T.J. Sweater Ltd. (11352)

27.MAY.2014

Identified Priority 1 Concerns

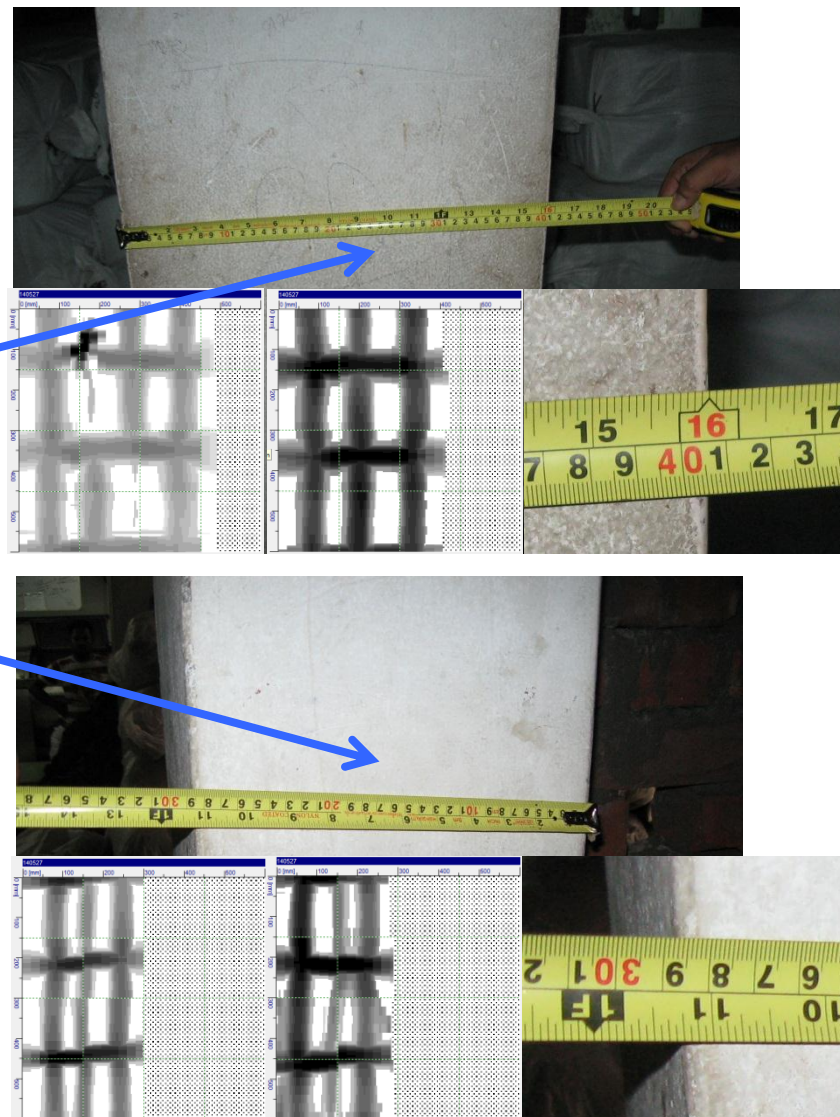
The actual conditions of column details of Building 1 do not match the details specified in the drawing.

Item No.	Observation	Recommended Action Plan	Recommended Timeline
9	Inconsistencies between the drawings of Building 1 and the actual as-built conditions.	Factory Engineer to survey the actual conditions and revise the drawings. Factory Engineer to review design, loads and columns stresses to confirm suitability for loads applied. Produce and actively manage a loading plan for all floor plates within this area giving consideration to floor capacity and column capacity.	6-weeks
10	Inconsistencies between the drawings of Building 1 and the actual as-built conditions.	Continue to implement load plan	6-months
11	Overall stability system.	Request that the Detail Engineering Assessment of the overall building to be carried out and in particular, stability and foundation aspects should be investigated in detail.	6-weeks
12	Distress due to water ingress.	Factory Engineer to inspect water damaged structures and repair with a suitable method.	6-weeks

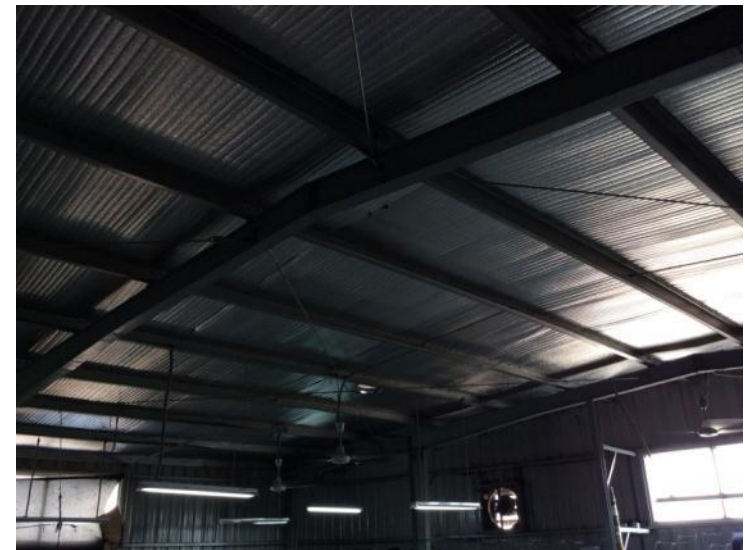
C4		C5	
	Drawing	In Situ	Drawing	In Situ
Size	15"x 10"	10" x 10"	18" x 10"	18" x 15"
Vert. rebar	8-20mm ϕ 2-16mm ϕ	8-20mm ϕ	10-20mm ϕ	10-20mm ϕ
Stirrups	10mm ϕ @7"	10mm ϕ @8"	10mm ϕ @7"	10mm ϕ @8"

Remark: Assumed rebar size in situ are the same size as shown in the drawing.
